Judiciary of Guam

MEMORANDUM:

Subject: Amendment No. 5
Re: RFP 25-06; Upgrade of Access Control Systems and Provide & Install Closed Circuit Television (CCTV) for the Forensic Lab Building, Mangilao, Guam

ATTACHMENT 1

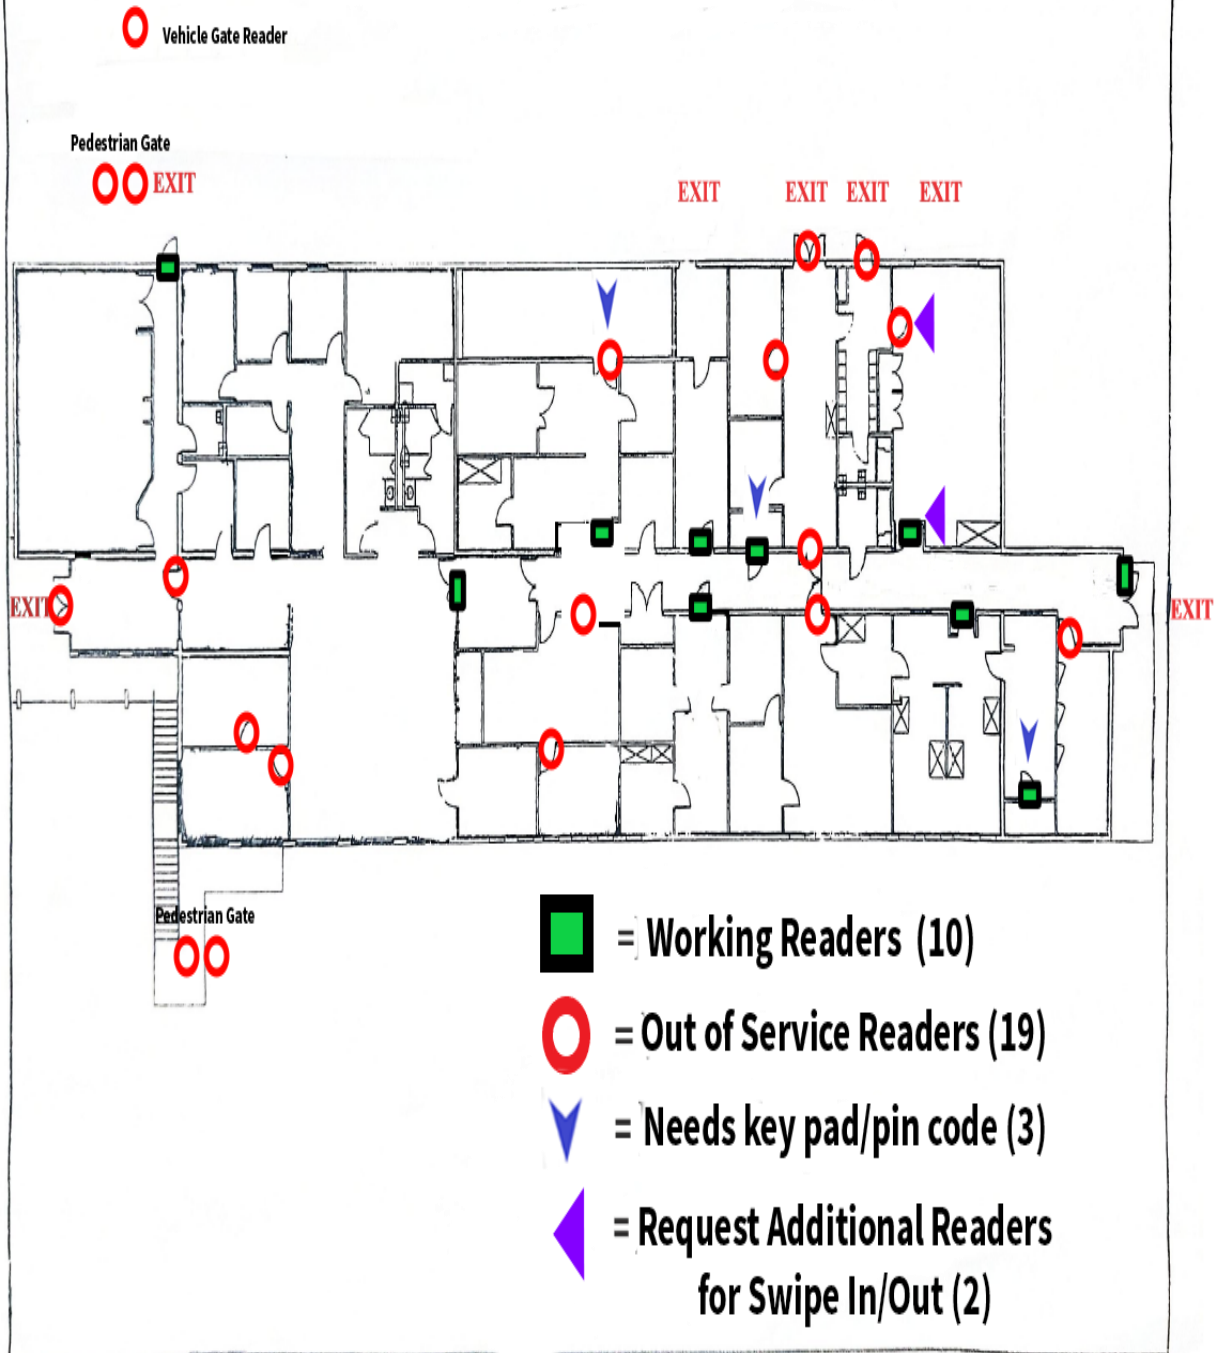
1. Please provide the floor plan indicating existing RFID doors, new RFID doors, and CCTV camera placements (s).

22. Please provide a comprehensive listing of the current status of all existing door strikes, as discussed during the site assessment.

Response: For doors, please see **Attachment 1**.

Response: Please see **Attachment 1** for layout location and **Attachment 2** for listing.
